Infrastructure Report

Project:
Carlisle Residential
Development, Kimmage Road
West, Kimmage, Dublin 12

Job No.
21.221

Document No: 21.221 – IR – 01

Figure 6.2 – Updated Access Road Layout with traffic calming measures

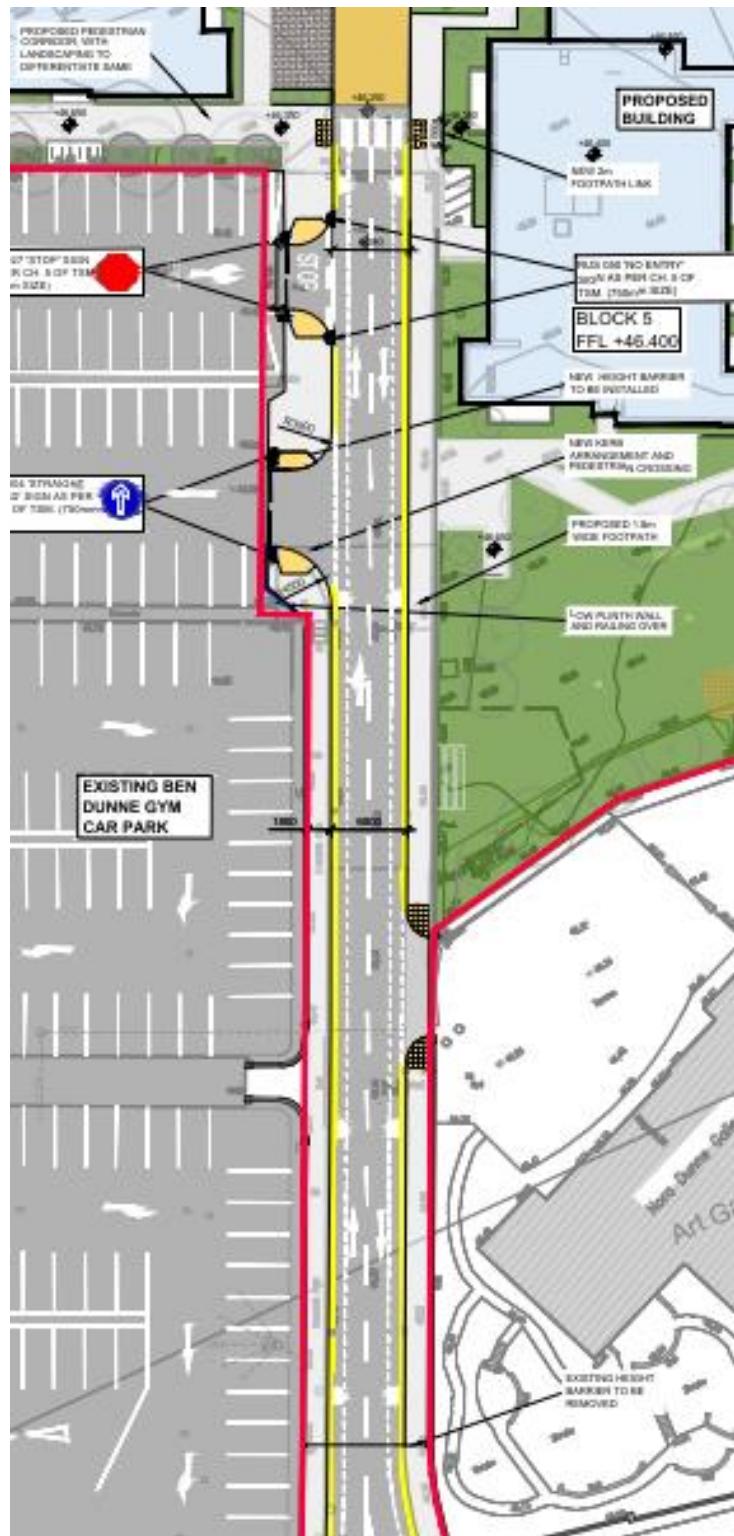
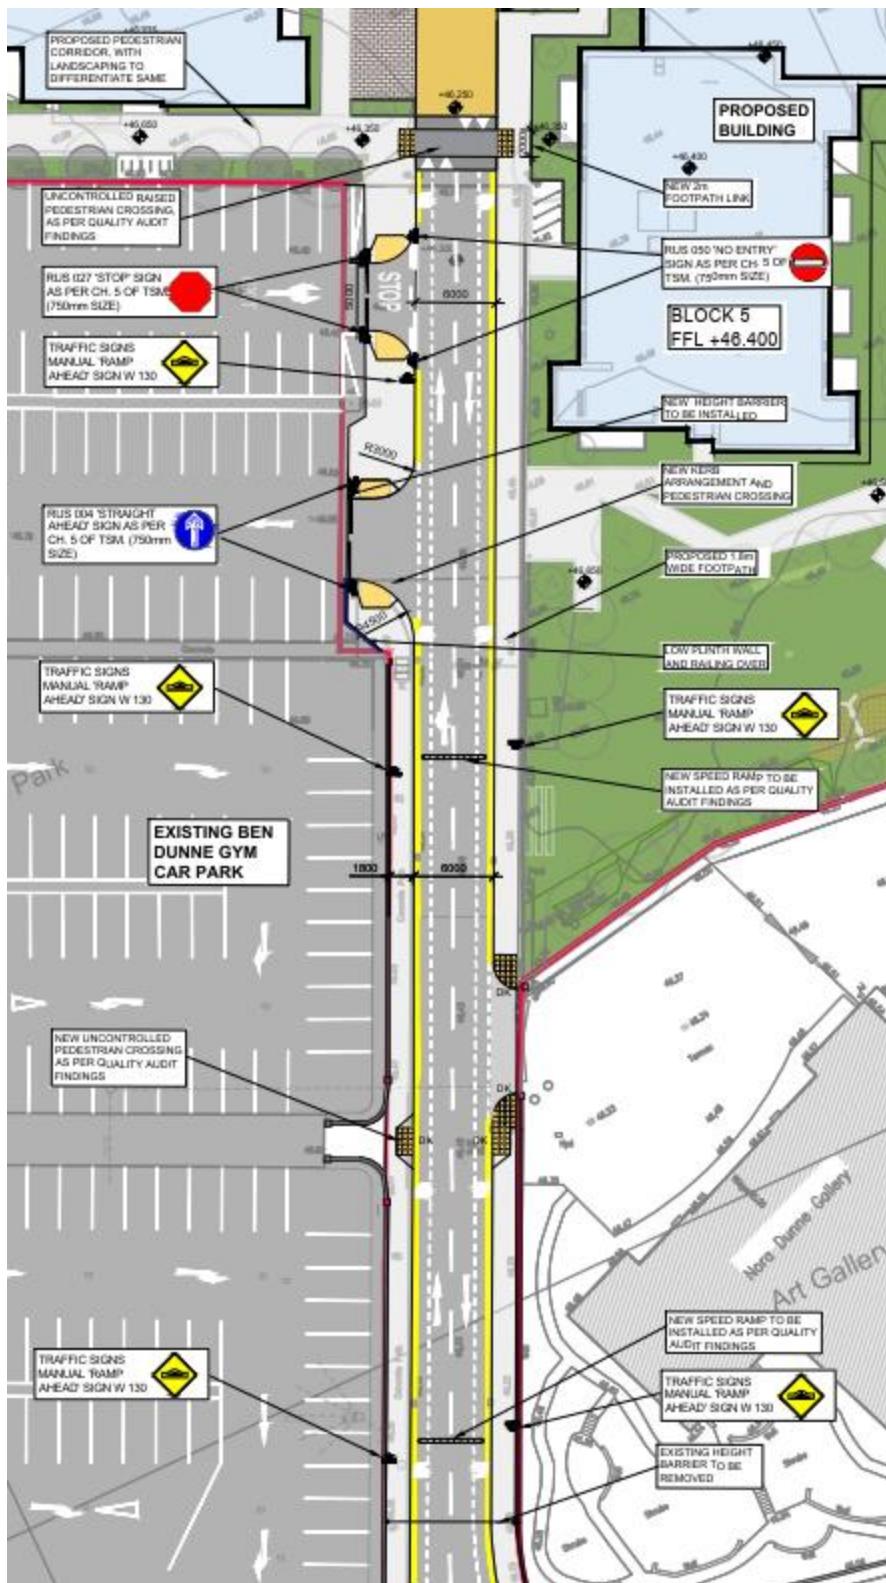
Access road is noted to be relatively straight and relatively long, which will lead to high vehicle speed and as a result high injury severity if a pedestrian or cyclist is struck by an errant vehicle.

Traffic calming measures have been provided through the use of speed ramps along the access road to the site. See BMCE drawing CST-BMD00-ZZ-DR-C-1017.

Figure 6.4 – Updated Pedestrian Desire Line to Ben Dunne Gym

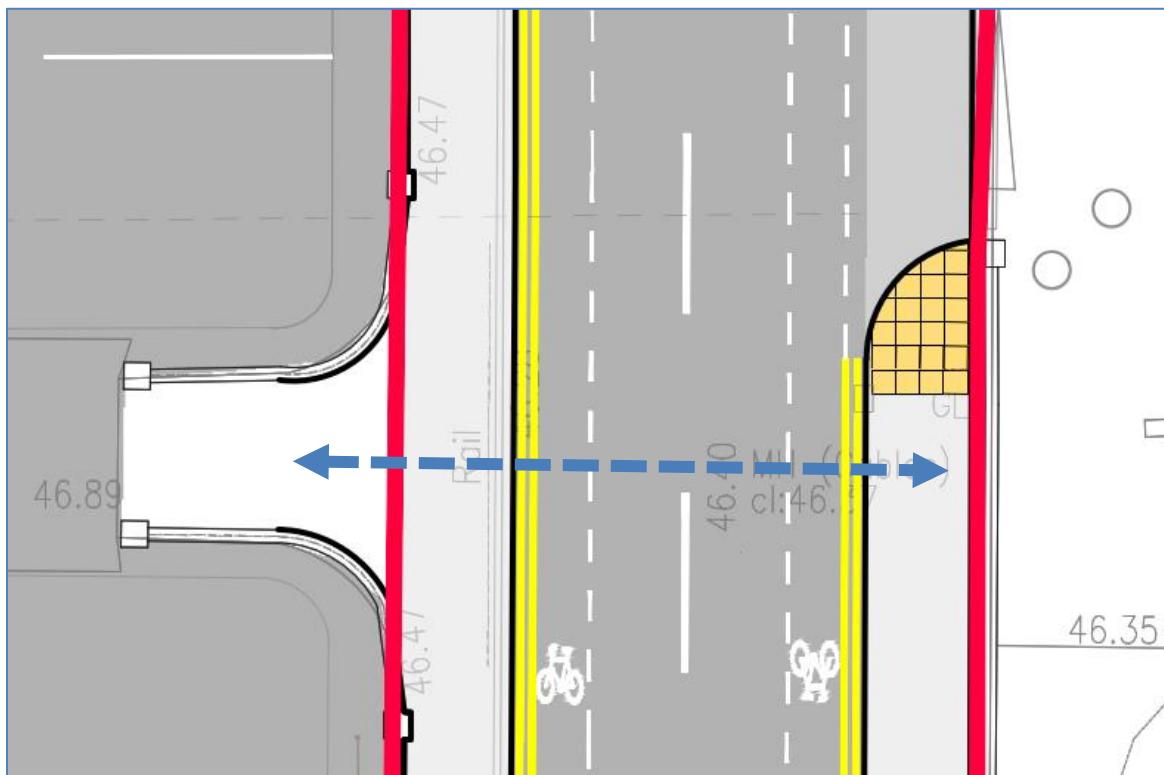
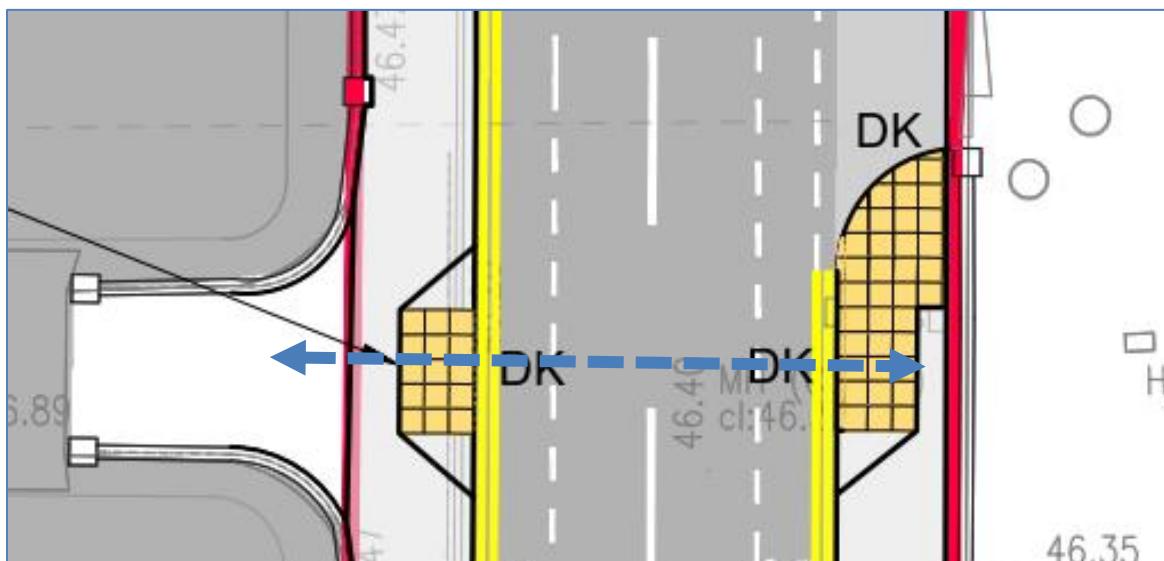
There will be a pedestrian desire line across the main access road to the pedestrian only access to the Ben Dunne Gym. Without the provision of dropped kerbs this could lead to trips and falls.

Based on the recommendations, dropped kerbs and suitable tactile paving is to be provided to cater for the pedestrian desire line. See BMCE drawing CST-BMD00-ZZ-DR-C-1017.

Figure 6.6 – Updated Pedestrian Crossing at start of shared road

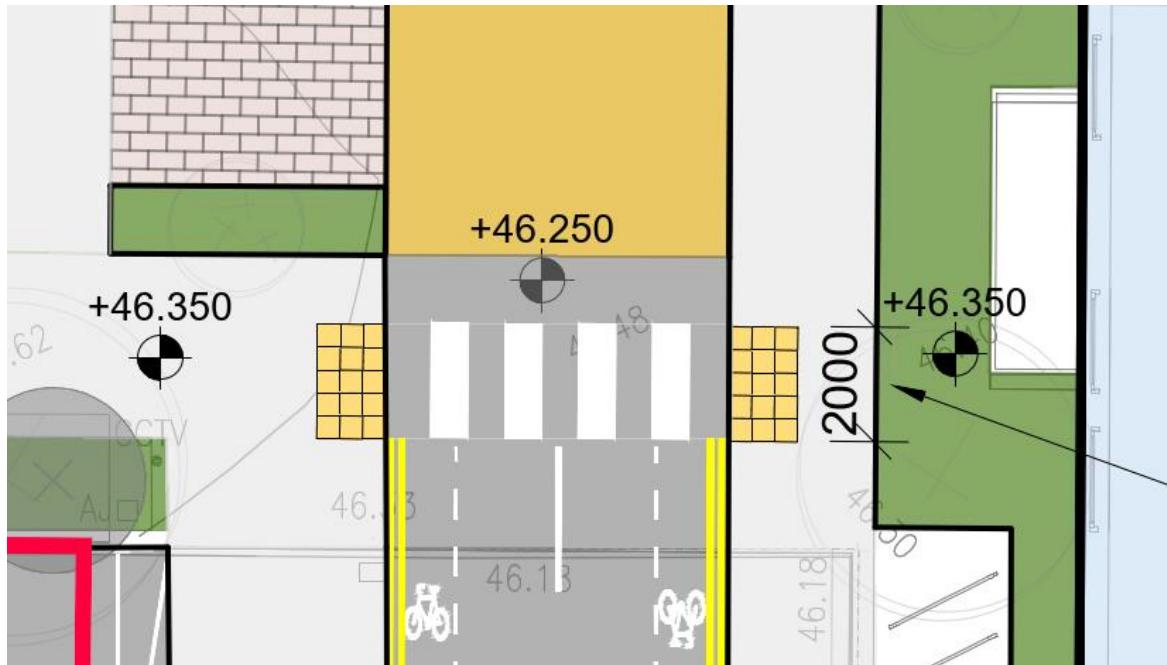
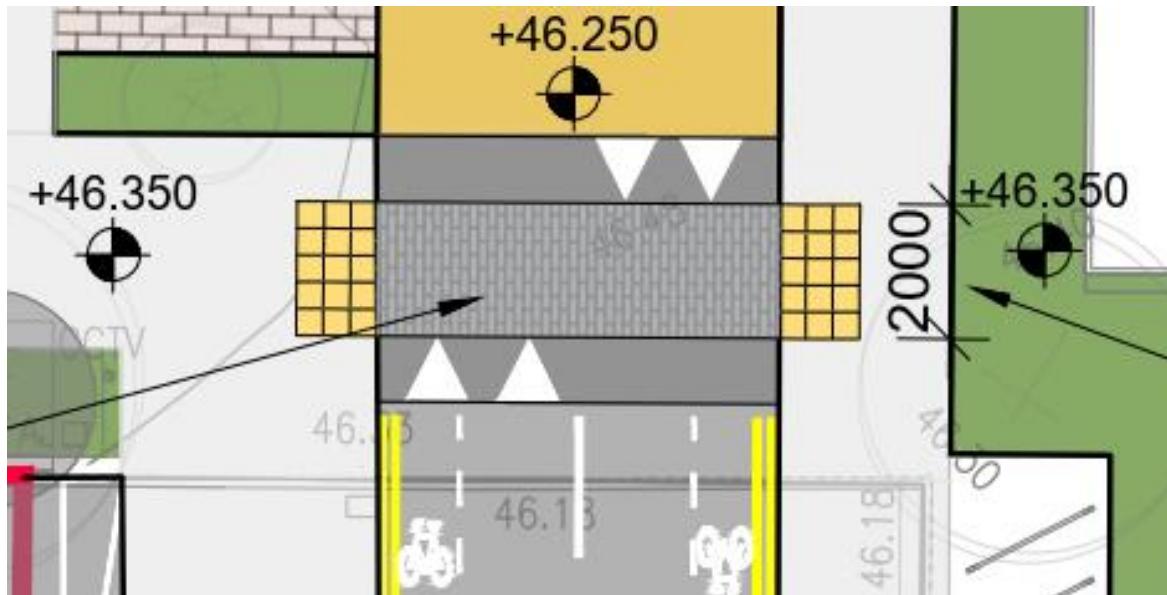
Proposed pedestrian crossing at the start of the shared use road was highlighted. The proposed zebra type black and white stripes may lead to confusion over priority, with pedestrians thinking they have priority due to the stripes while drivers may think otherwise due to the lack of flashing beacons. This confusion may lead to collision between vehicles and pedestrians.

Based on the Quality Audits recommendations the stripes have been removed and an uncontrolled pedestrian crossing is proposed. See BMCE drawing CST-BMD00-ZZ-DR-C-1017.

Figure 6.8 – Updated Surface Water Layout with gullies

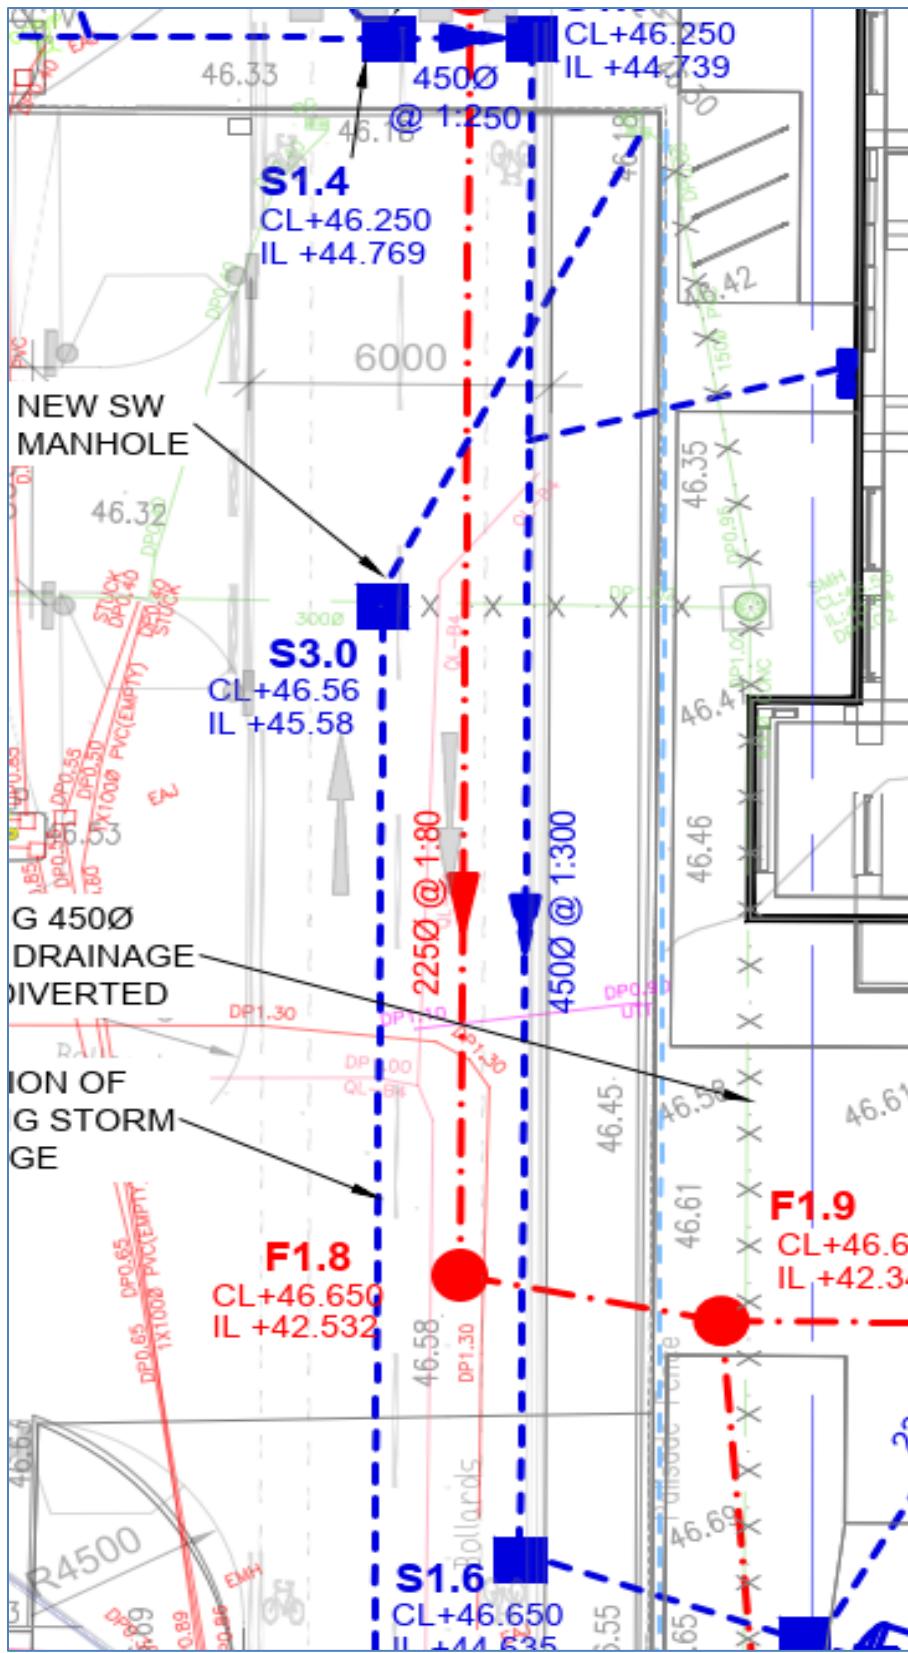
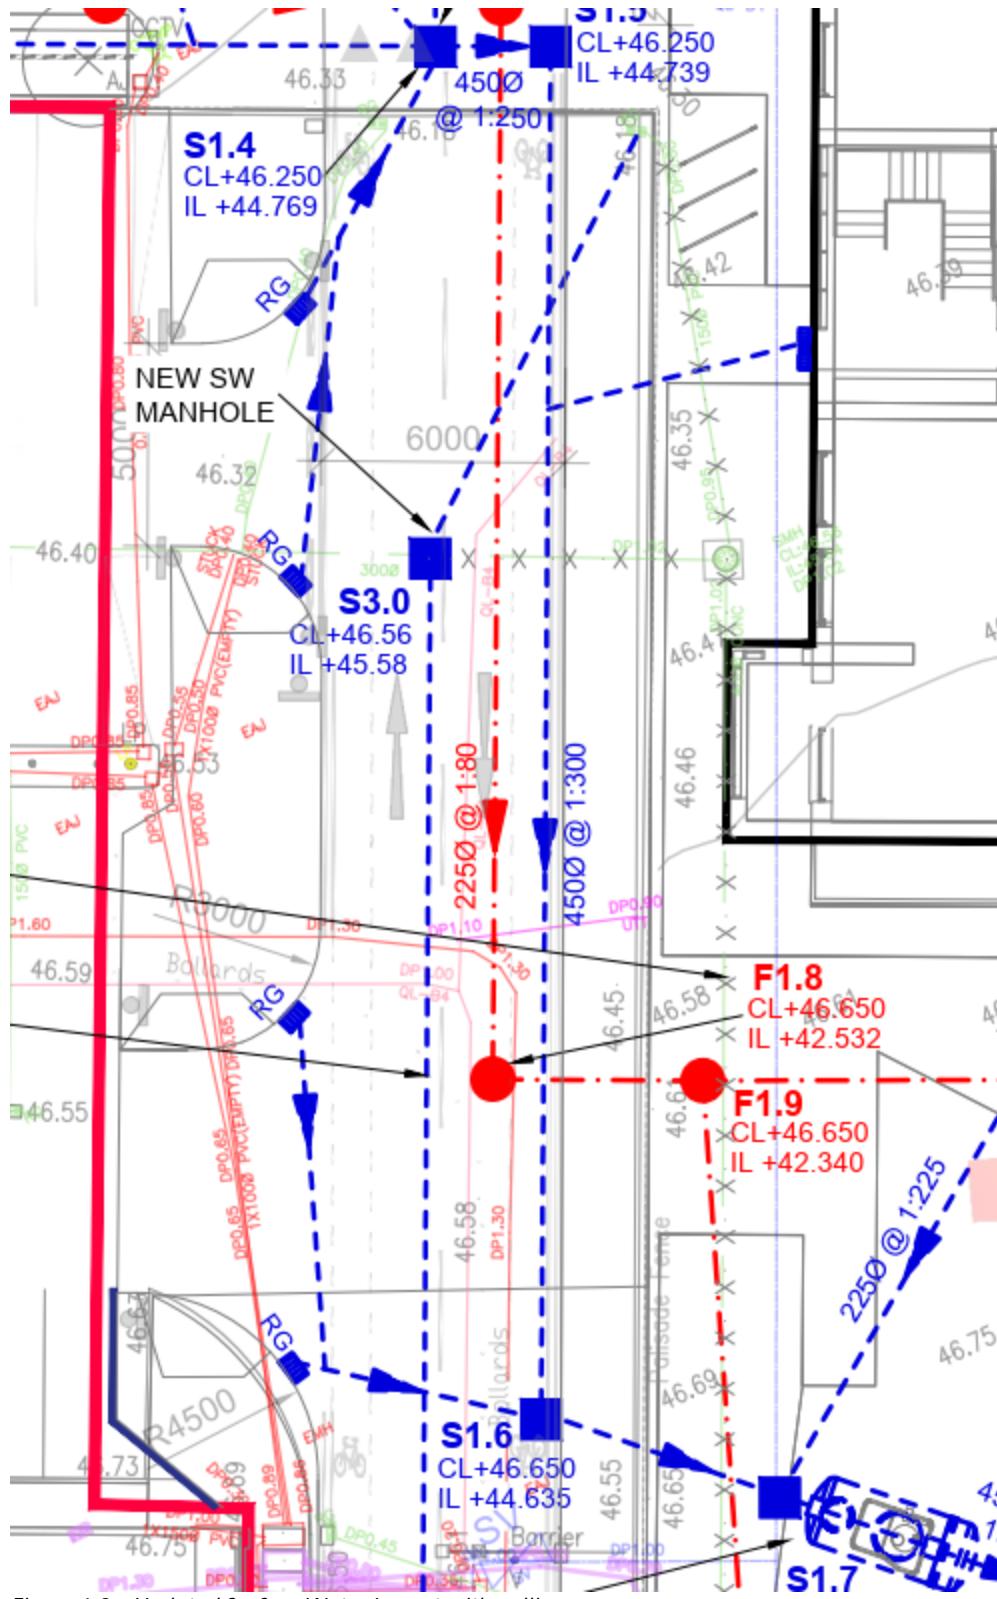
A risk of surface water ponding was noted at the dropped kerb locations for uncontrolled pedestrian crossings if there are not adequate drainage provision upstream of each crossing. This could lead to slips and falls in wet or icy conditions.

Gullies have now been proposed immediately upstream of all dropped kerbs to prevent this issue. See BMCE drawing CST-BMD-00-ZZ-DR-C-1002.

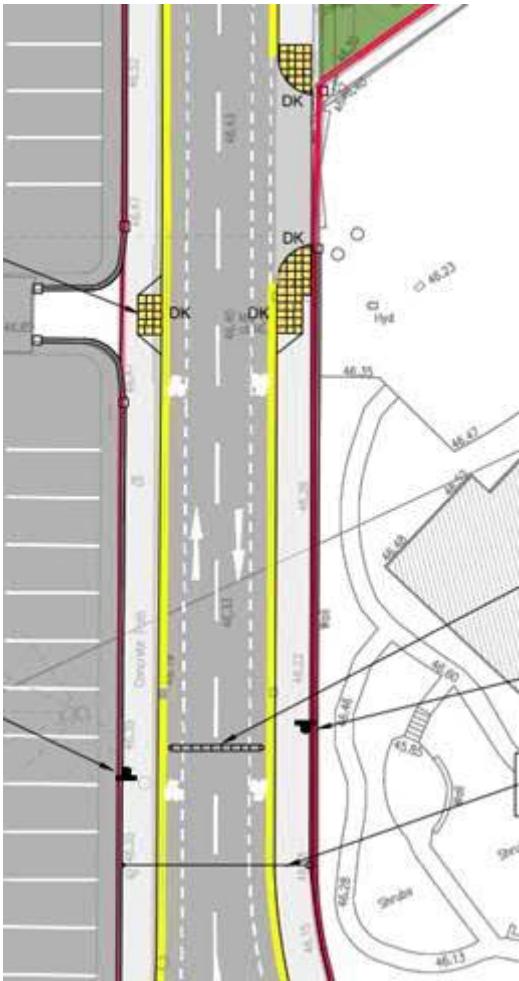
The changes to the carriageway width and the addition of a footpath on the eastern side of the access road are noted. However, the advisory cycle lanes will provide limited benefit to cyclists accessing/egressing the proposed development. This is especially the case on approach to the junction with Kimmage Road West. The retention of the dual lane exit from the access road onto Kimmage Road West will in this division's opinion negate any advantage of reducing laneway widths further north of the dual lane exit by providing a wide carriageway which may encourage driver speeds. It is unclear if the benefit of a 'pedestrian priority' raised table mitigates the wide pedestrian crossing provided. As noted at Stage 2 by this division, the overall context of the access road is proposed to change having regard to the reliance on active travel modes to and from the proposed development.

- Where the existing access road narrows (at the Nora Dunne gallery site – see drawing extract below), we physically don't have the space available within the extg road reservation, to introduce segregated cycle lanes and still achieve the additional eastern footpath. So we have to work within that constraint, for that section of the road at least. We should not lose the second footpath on the eastern side of the road, and so the cycle lanes must be 'on-carriageway' .
